MONTECITO PLANNING COMMISSION

Staff Report for Babbit et al. Appeals of Scibird Exterior Alterations (Case Nos. 21LUP-00000-00292 & 22BAR-00000-00187)

Hearing Date: January 17, 2024 Deputy Director: Travis Seawards
Staff Report Date: January 2, 2024 Division: Development Review
Case No.: 23APL-00031 & 23APL-00033 Supervising Planner: Errin Briggs

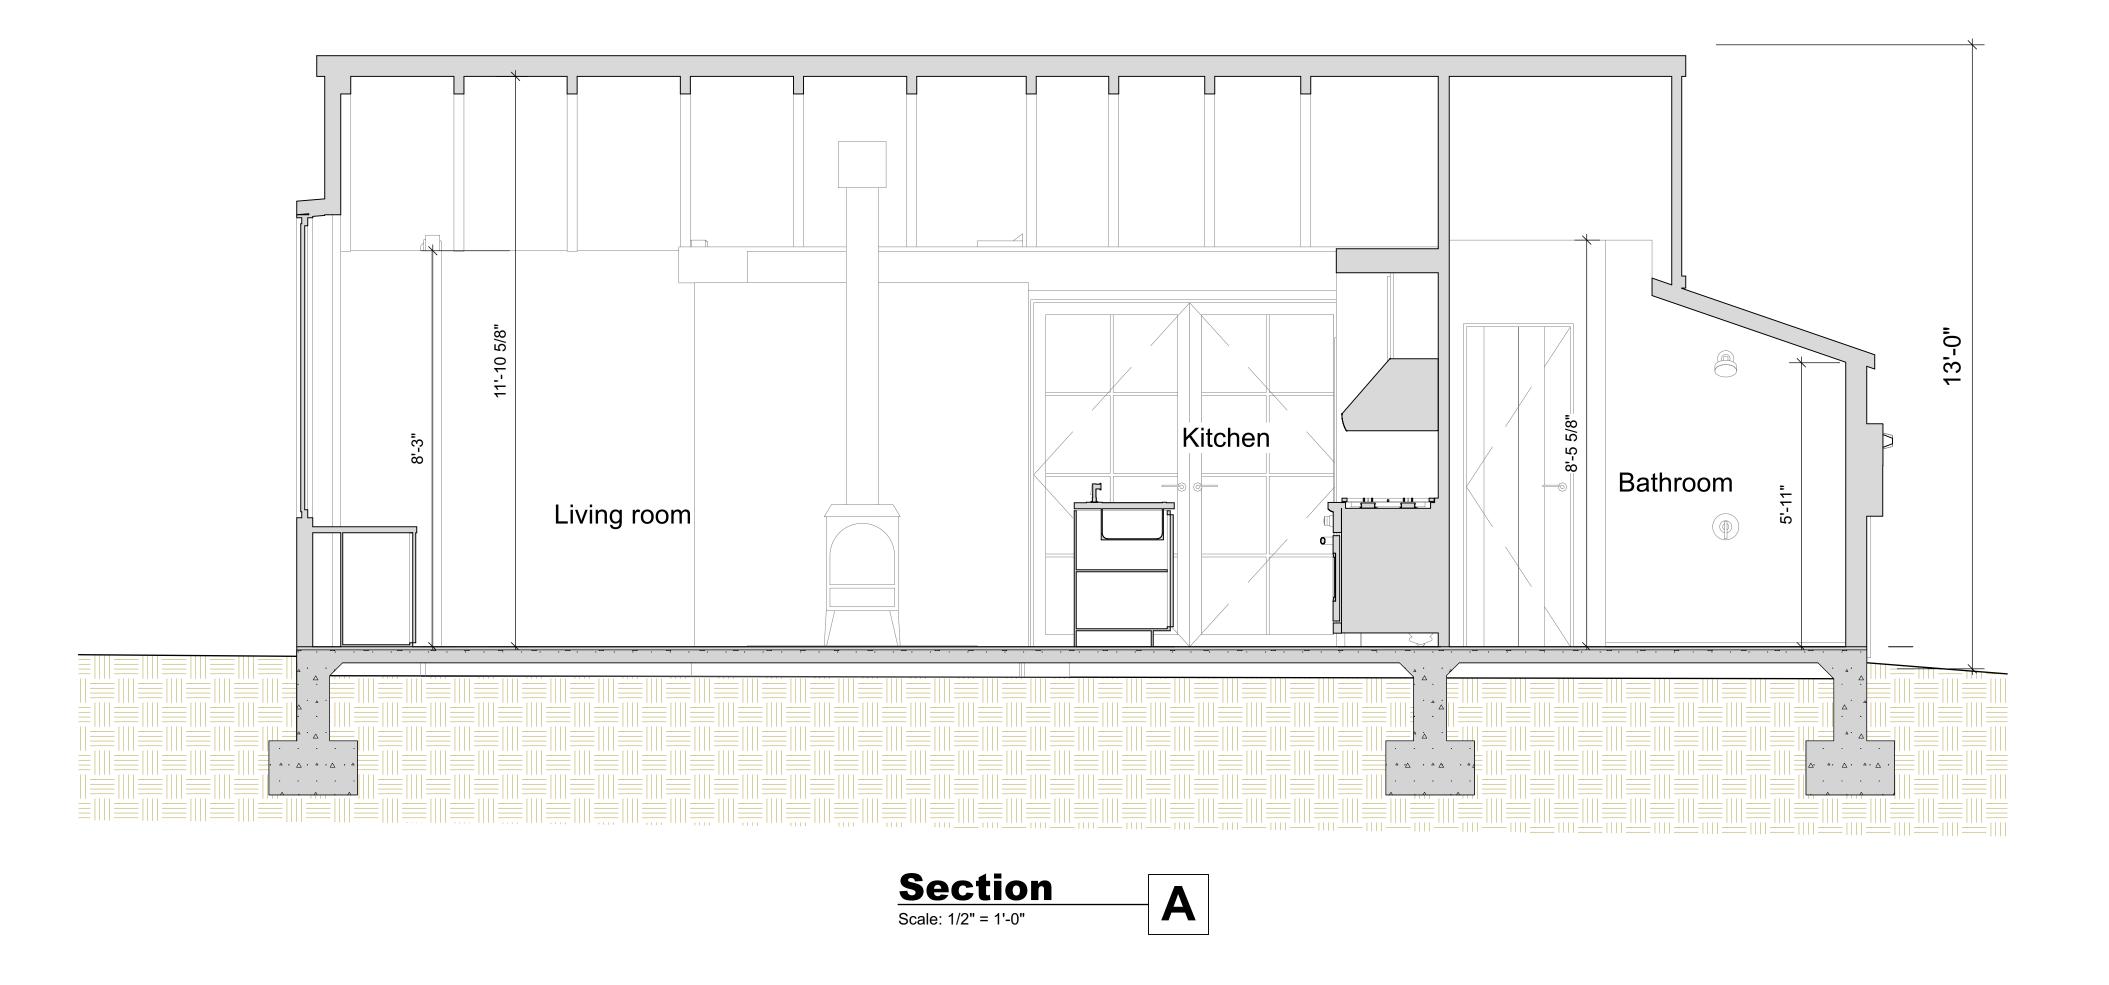
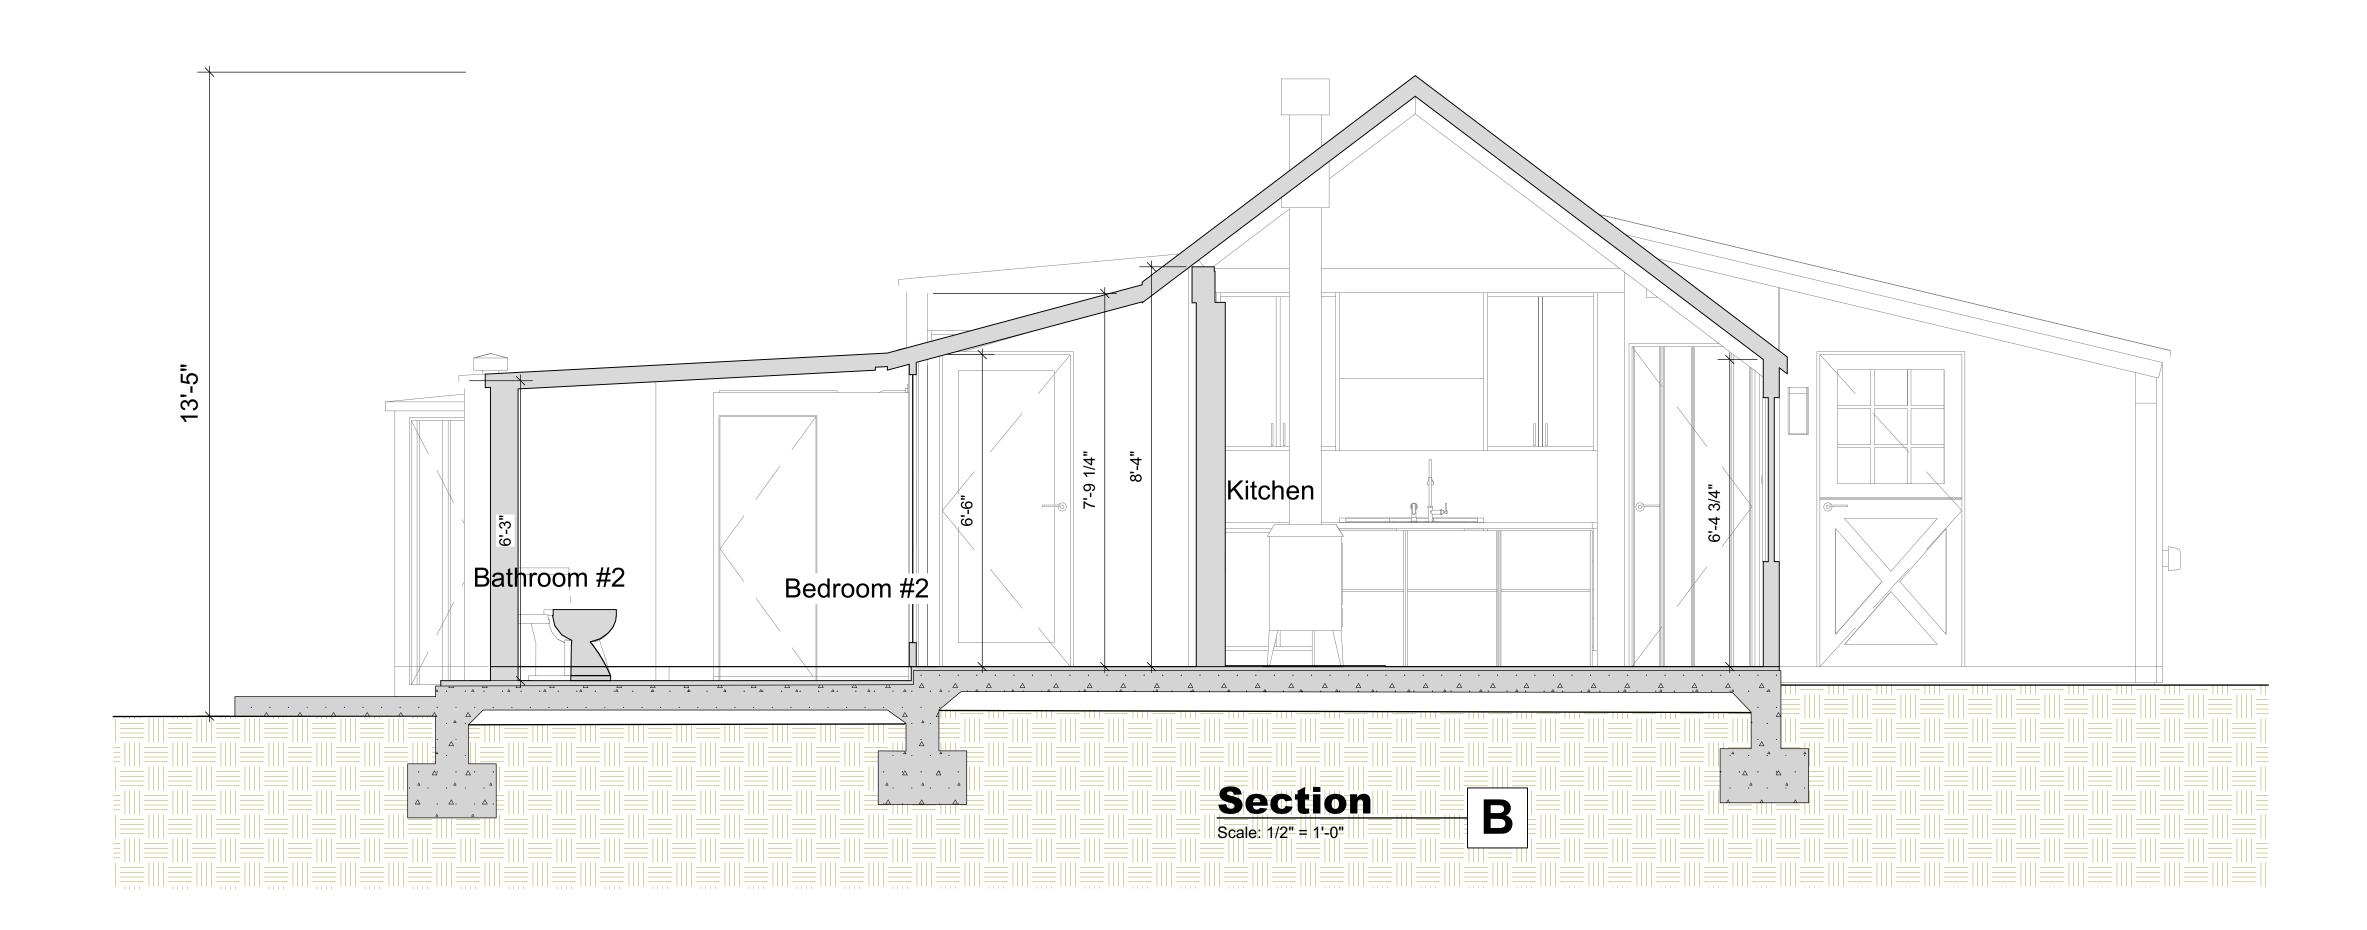
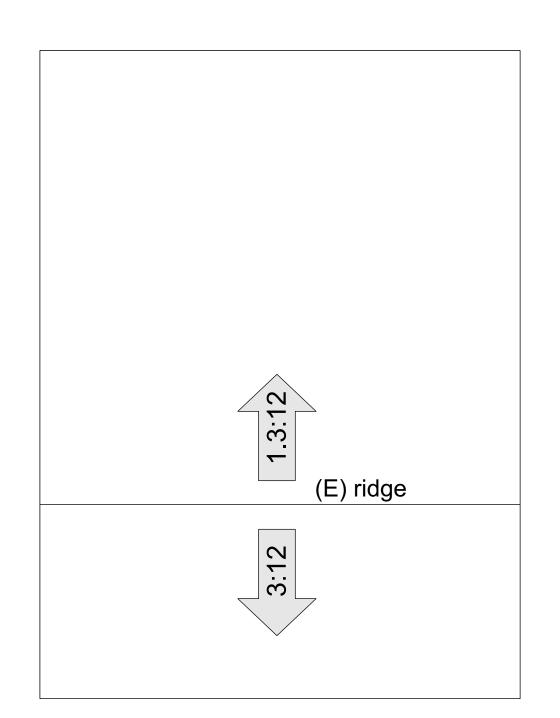
Provided the following measures are implemented the proposed project meets the Secretary of the Interior's Standards for Rehabilitation:

- Replacement board and batten siding shall match the original in material and appearance;
- Replacement windows shall match the appearance of the house's historic window types in regard to the type and appearance of glazing bars;
- _- An original window at the north end of the west elevation proposed for replacement shall be retained in place; and
- Consider revising the water heater door to incorporate some board and batten siding. See page A7, water heater door with matching board and battens

Provided the following measures are implemented the proposed project meets the Secretary of the Interior's Standards for Rehabilitation:

- Replacement board and batten siding shall match the original in material and appearance;
- _- Replacement windows shall match the appearance of the house's historic window types in regard to the type and appearance of glazing bars; and
- An original window at the north end of the west elevation proposed for replacement shall be retained in place

- Consider revising the water heater door to incorporate some board and batten siding. —

Figure 20, Proposed floor plan

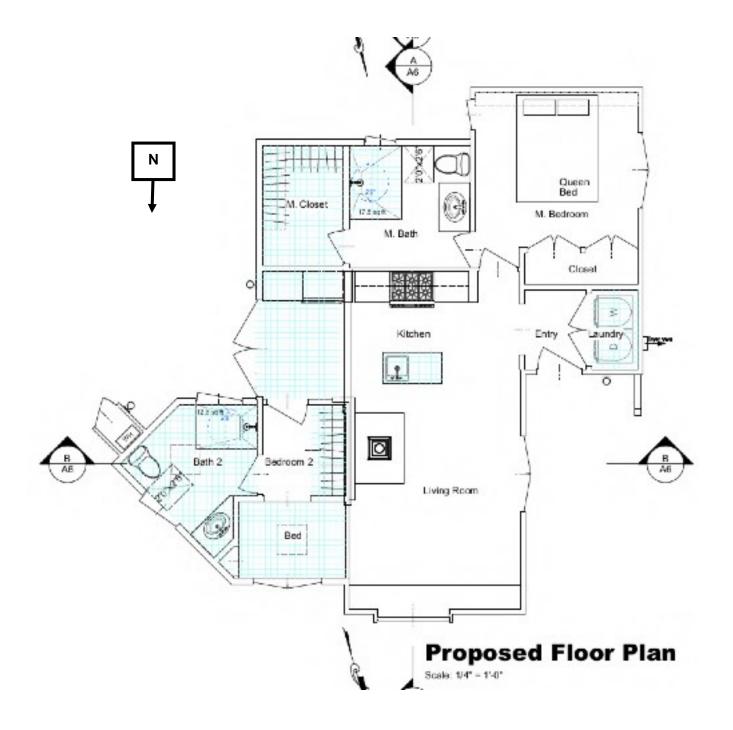
West Elevation (see Figures 19, 20 and Figures 27 & 28):

Replace a window in a 1973 addition with a pair of four-light windows whose design emulates the house's historic window type; and • Replace an original set of three multi-light windows with a pair of four-light windows.
